Monticello Nuclear Generating Plant

License Amendment Request dated June 22, 1995

Proposed Changes Marked Up on Existing
Technical Specification Pages

~~Figure 3.5-1 Single Loop Operation Surveillance Power/Flow Curve~~

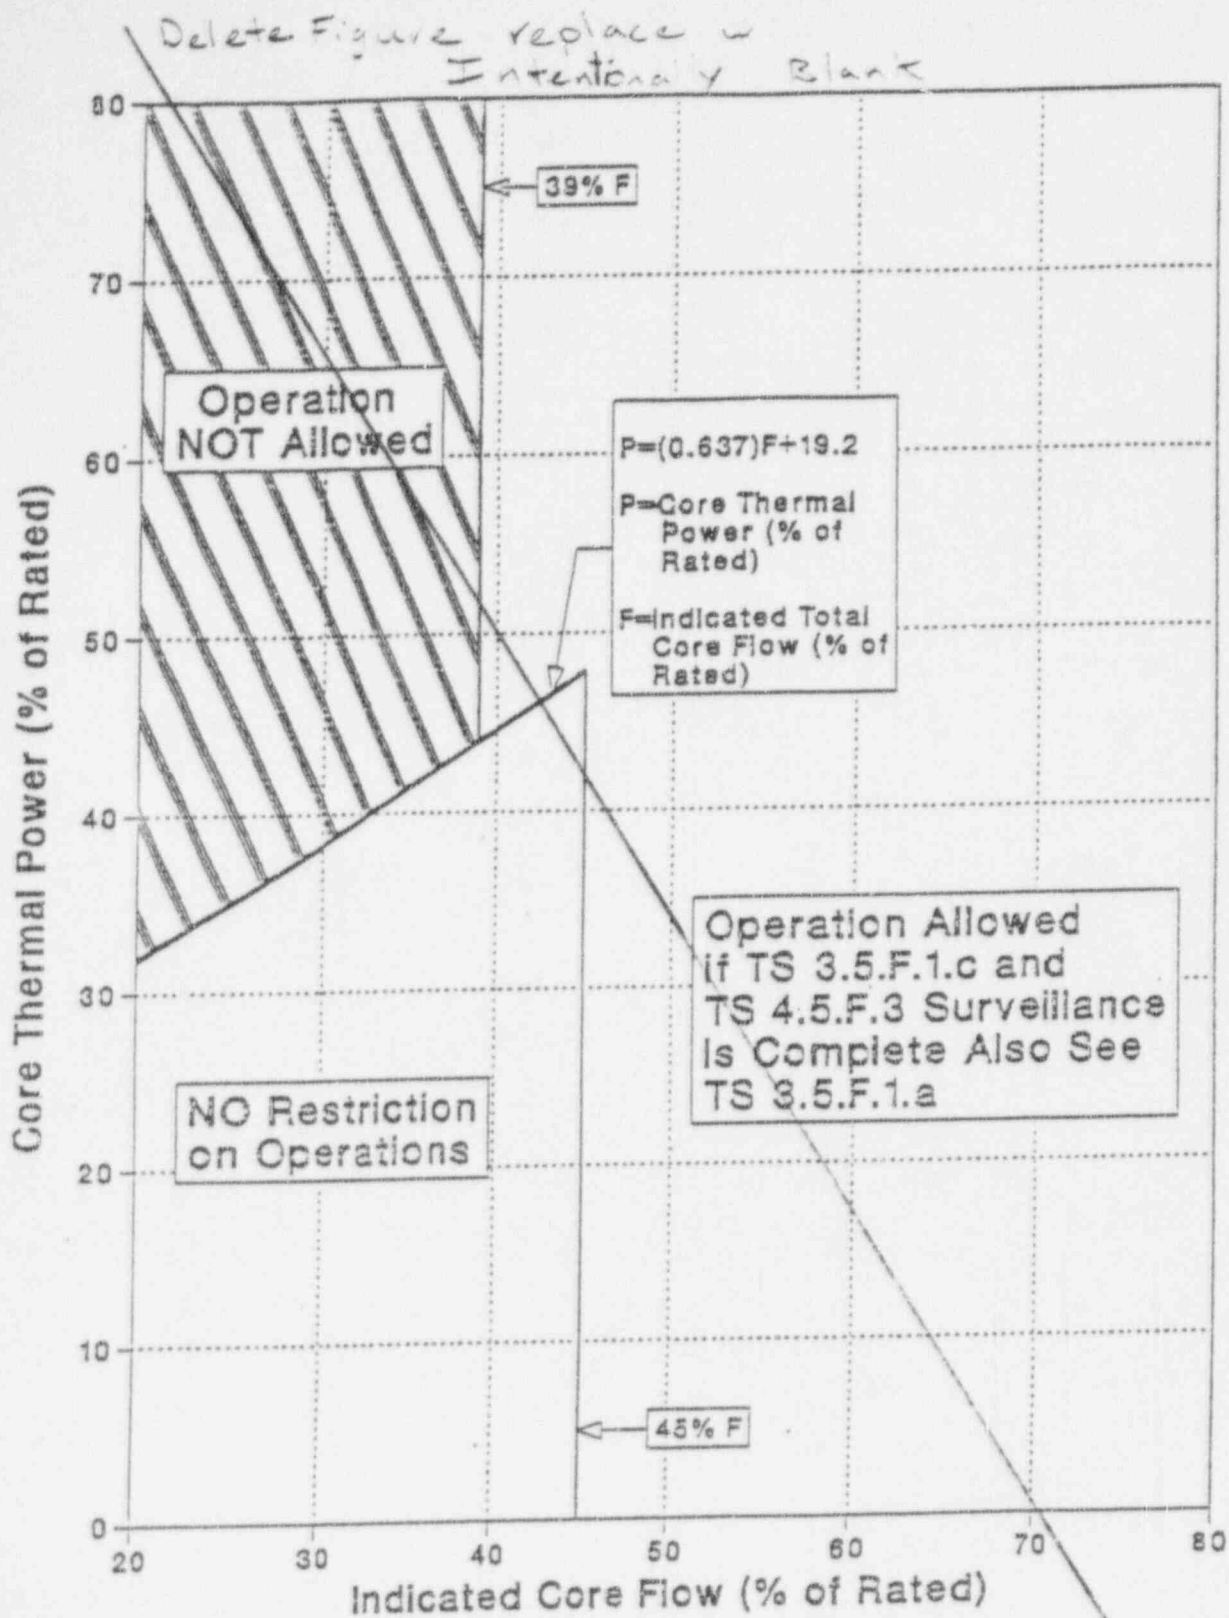
b. ~~Total core flow will be maintained greater than 39% when core thermal power is above the limit specified in Figure 3.5.1.~~
Technical specification 3.5.F.1 and 3.5.F.2 are met.

~~2. The following baseline noise levels will be obtained prior to operation with only one recirculation pump in operation at a core thermal power greater than that specified in Figure 3.5.1 or with a core flow greater than 45% provided that baseline values have not been established since the last core refueling. Baseline values will be taken with only one recirculation pump running.~~

~~3. With only one recirculation loop in operation at a core thermal power greater than that specified in Figure 3.5.1 or with a core flow greater than 45%, determine the following noise levels at least once per 8 hour period and within 30 minutes after a core thermal power increase of greater than 5% of rated thermal power.~~

~~b. reduce core thermal power to less than the limit specified in Figure 3.5.1.~~

1. Intentional entry into the stability exclusion region of the power-flow map defined in the Core Operating Limits Report (COLR) is prohibited. If entry into the stability exclusion region does occur, immediately perform one or more of the following until the stability exclusion region has been exited:
 - a. Insert control rods,
 - b. Increase the speed of an operating recirculation pump.
2. Entry into the stability buffer region of the power-flow map as defined in the COLR is prohibited unless the power distribution controls as defined in the COLR are in effect. If the power distribution controls are not in effect and entry into the stability buffer region does occur, immediately perform one or more of the following until the stability buffer region has been exited:
 - a. Insert control rods,
 - b. Increase the speed of an operating recirculation pump.

The reactor is designed such that thermal hydraulic oscillations are prevented or can be readily detected and suppressed without exceeding specified fuel design limits. To minimize the likelihood of a thermal-hydraulic instability, a power-flow exclusion region, to be avoided during normal operation, is calculated using the approved methodology as stated in specification 6.7.A.7. Since the exclusion region may change each fuel cycle the limits are contained in the Core Operating Limits Report. Specific directions are provided to avoid operation in this region and to immediately exit upon an entry. Entries into the exclusion region are not part of normal operation. An entry may occur as the result of an abnormal event such as a single recirculation pump trip. In these events, operation in the exclusion region may be needed to prevent equipment damage, but actual time spent inside the exclusion region is minimized. Though operator action can prevent the occurrence and protect the reactor from an instability, the APRM flow biased scram function will suppress oscillations prior to exceeding the fuel safety limit.

Power distribution controls are established to ensure the reactor is operated within the bounds of the stability analysis. With these controls in place, there is confidence that an oscillation will not occur outside of the stability exclusion region. Without these controls, it is theoretically possible to operate the reactor in such a manner as to cause an oscillation outside of the exclusion region. A nominal 5% power-flow buffer region outside of the exclusion region is provided to establish a stability margin to the analytically defined exclusion region. The buffer region may be entered only when the power distribution controls are in place.
